**NO. 29 NEW END
HAMPSTEAD
LONDON, NW3 1JD
FOR KARAWANA LTD**

**PROPOSAL TO PROVIDE ADDITIONAL SUPPORT TO
SOUTHERN MOST BUTTRESS / RETAINING WALL**

GB/8082 – Revision 1.0

Scale	Date	Drawn
NTS	25.02.12	GB
Job No.	Drawing No.	Rev.
8082	CM03	C

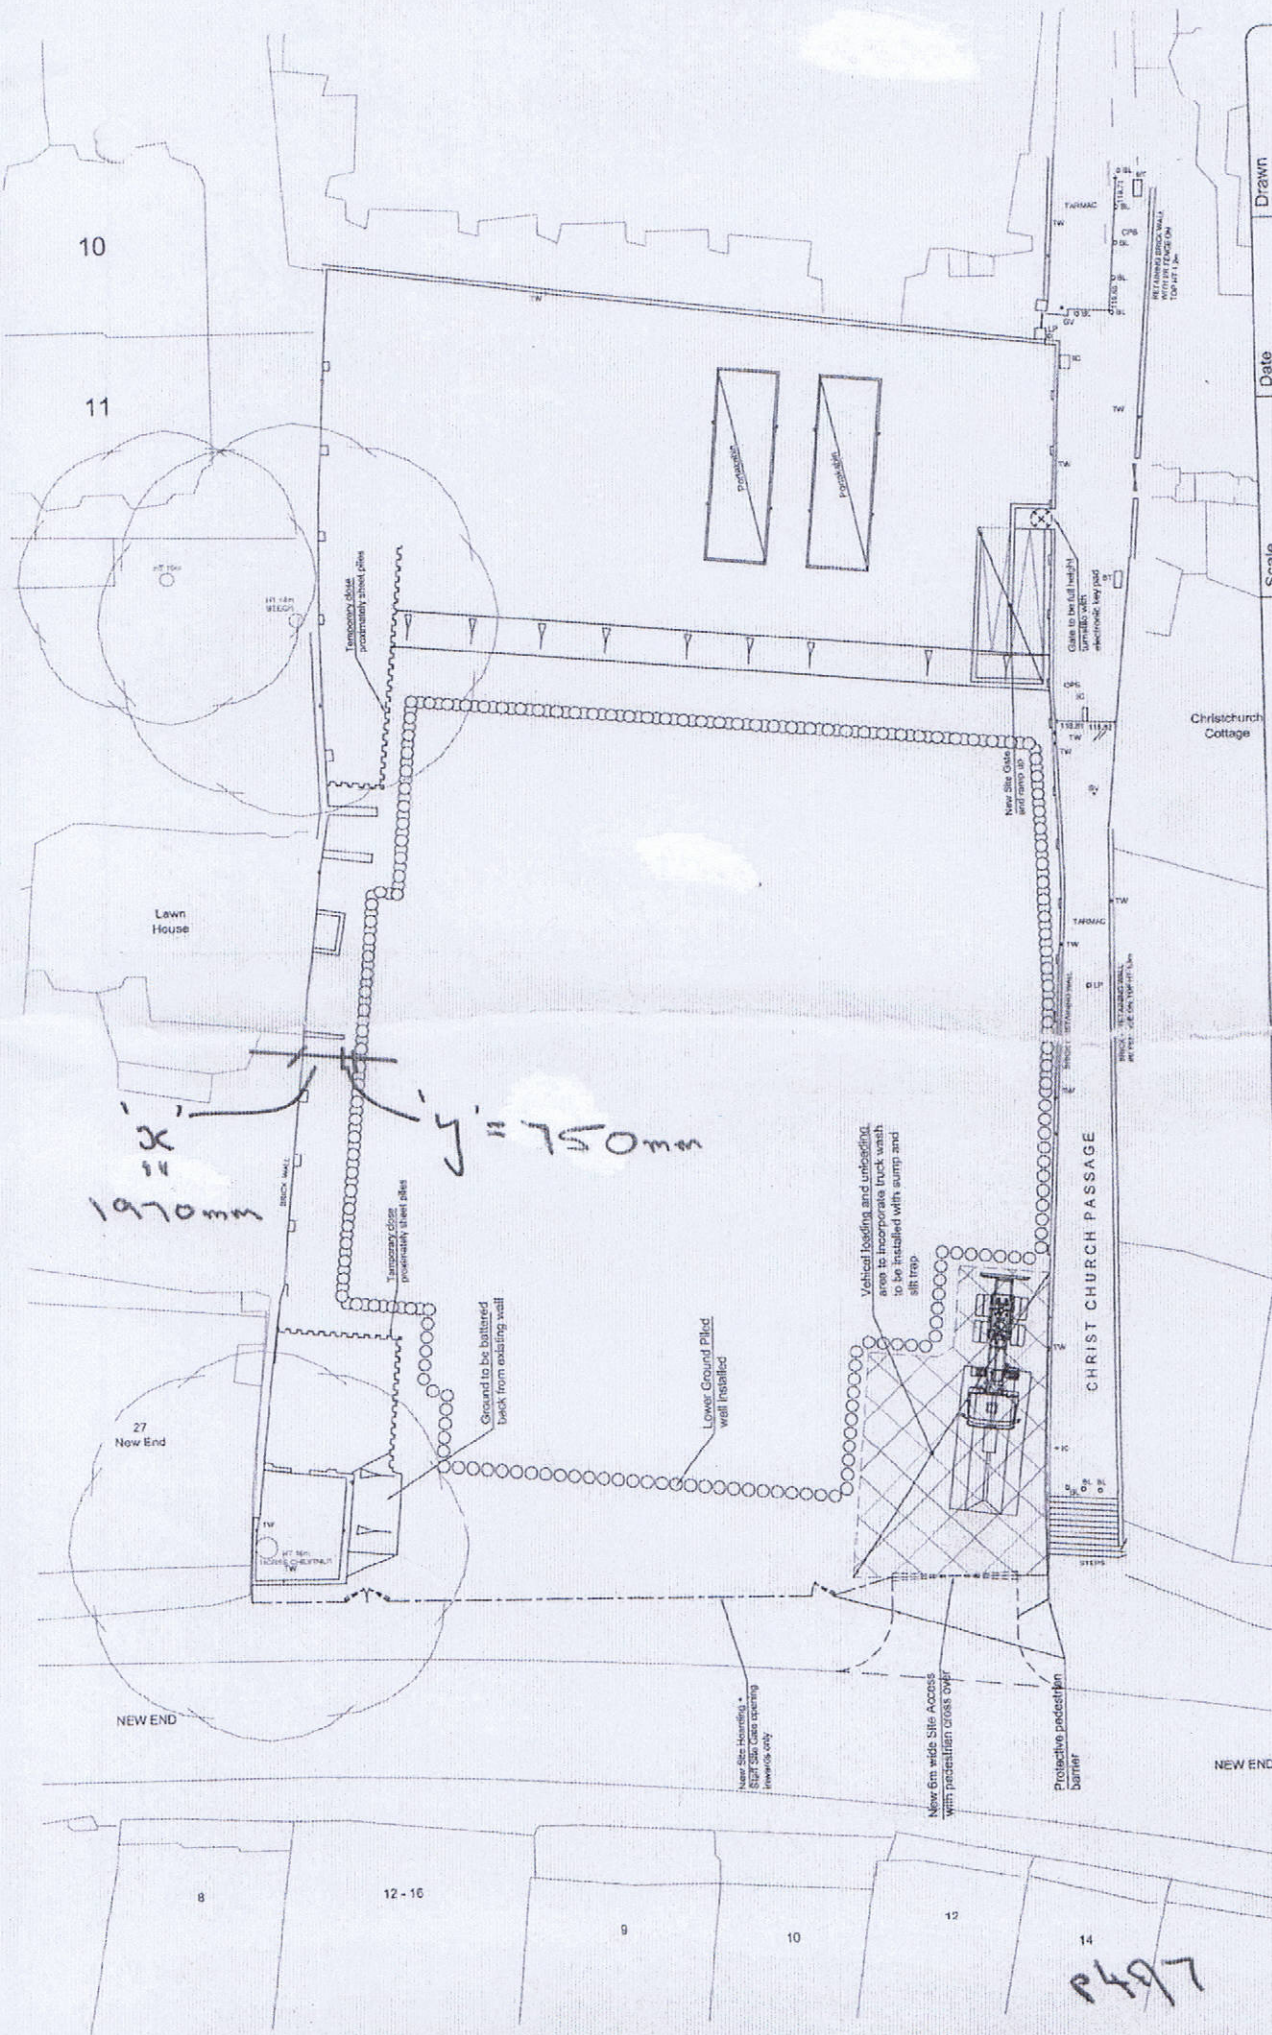
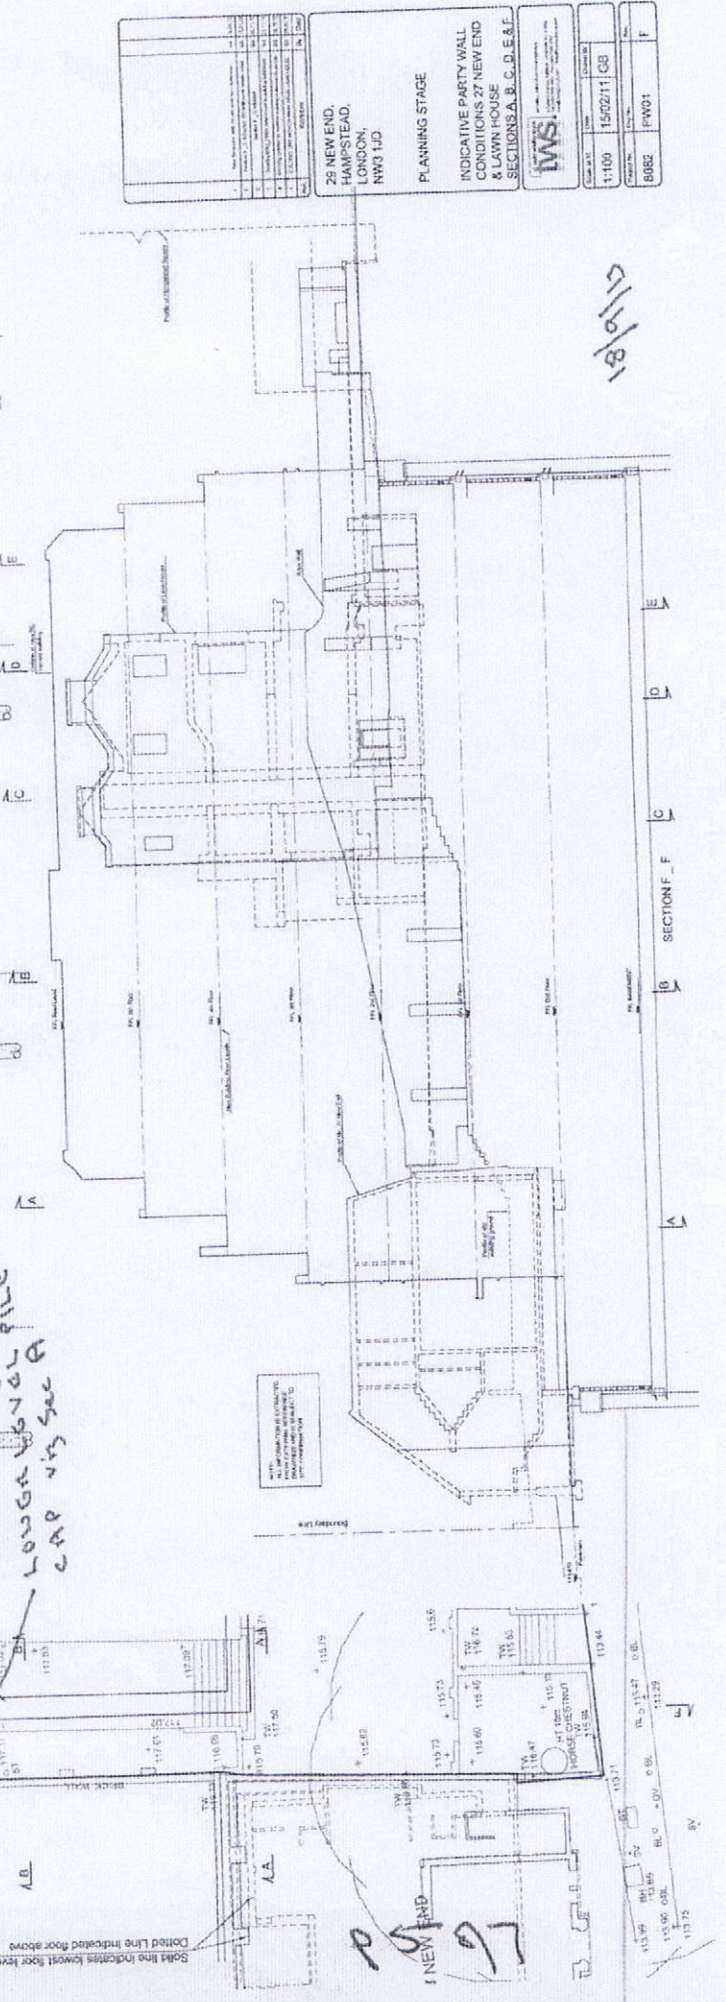
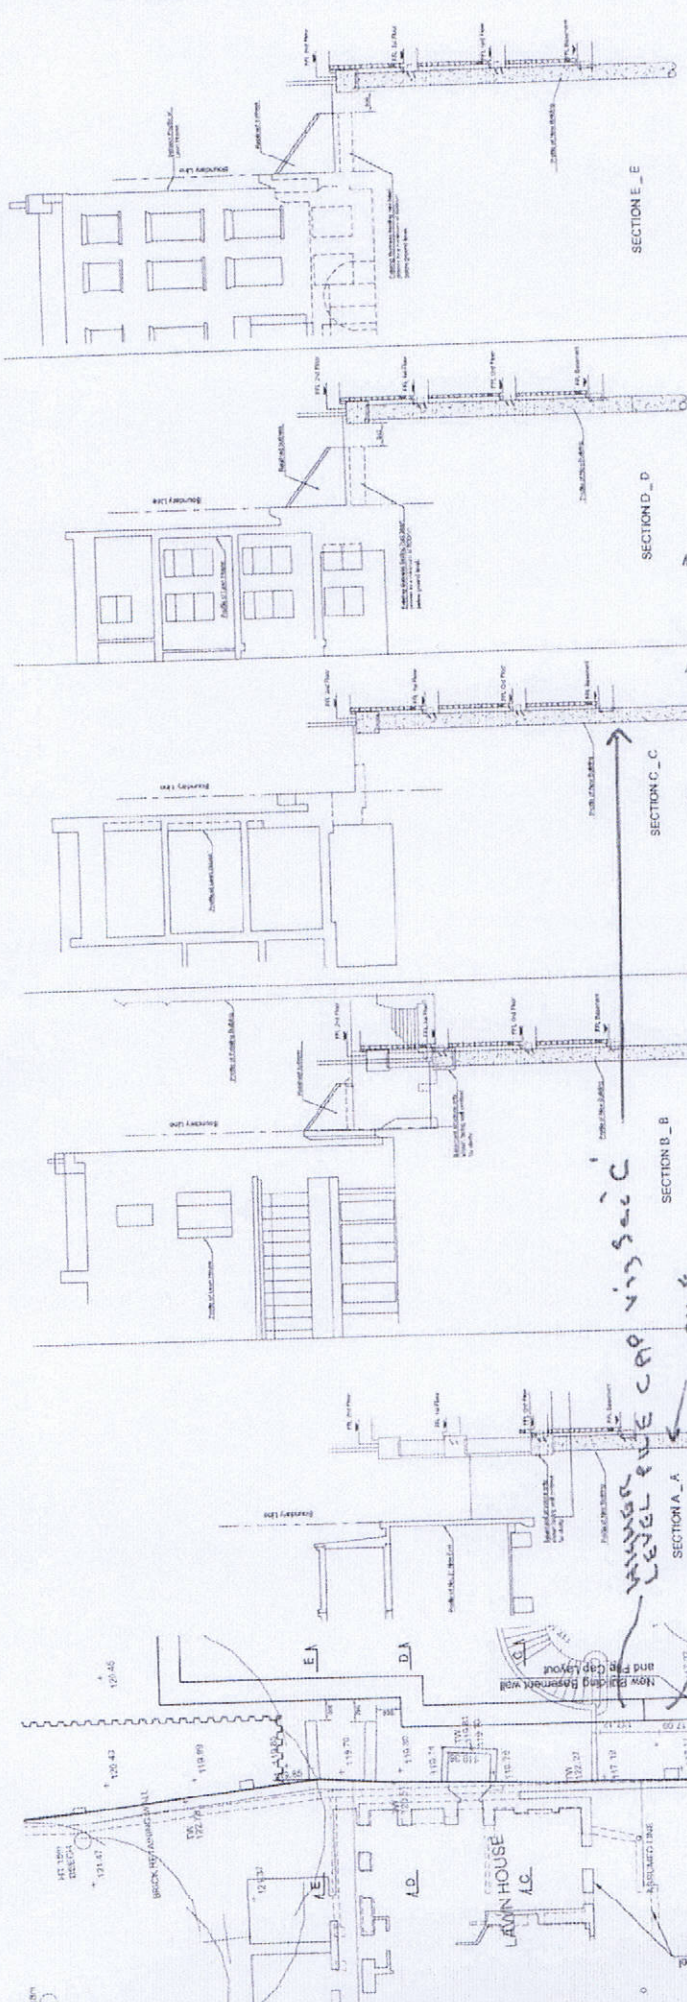
- 2.3 At a cut length of 1970mm the clear distance between the end of the retaining wall and the face of the piles will be 750mm (see hand annotated drawing CM03revC p4of7).

- 2.2 The proposal is to cut vertically through the retaining wall at the toe of the buttress leaving the buttress intact and of overall projection from the garden wall circa 1970mm.
